TYPE "C" CATCH BASIN

DOCUMENT REVIEWED FOR CONFORMANCE WITH
DESIGN CONCEPT. CONTRACTOR SHALL VERIFY ALL
FIELD CONDITIONS AND PROVIDE QUANTITIES
REQUIRED BY CONSTRUCTION DOCUMENTS.

TOWNGATE
VILLAGE II

TRI-COUNTY CONCRETE PRODUCTS

NO.	3
ELEV.	5.56
INV.	2.15
HT.	3.41 +1.5 4.91
CUT	59"
PRICE	-208

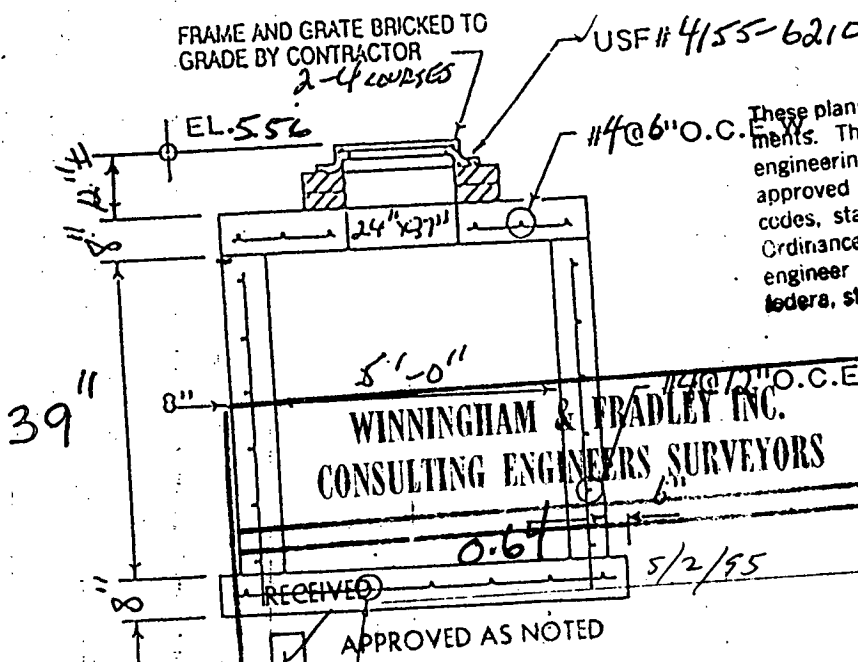
#4 @ 2' O.C. E.W. D.R.B. 5/3/95

NO.	12
1. ELEV.	6.30'
Inv.	1.50
HT.	4.80
CUT	58"
PRICE	+18 Sump -20 Sta 56"

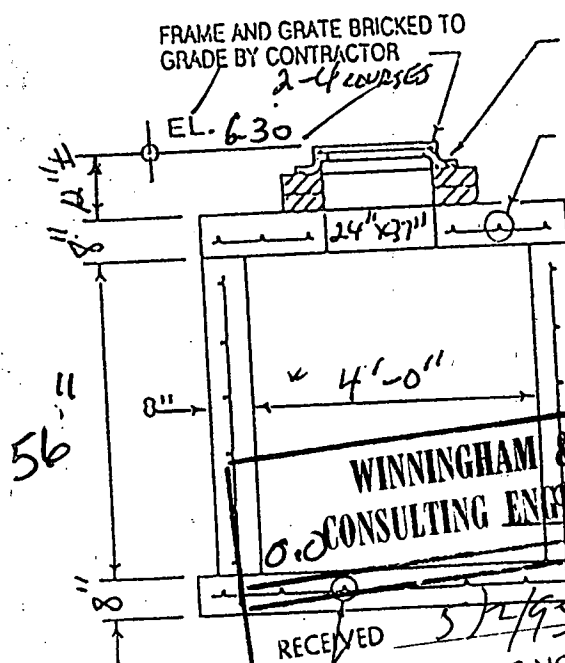
#4 @ 6" O.C.E.W. date
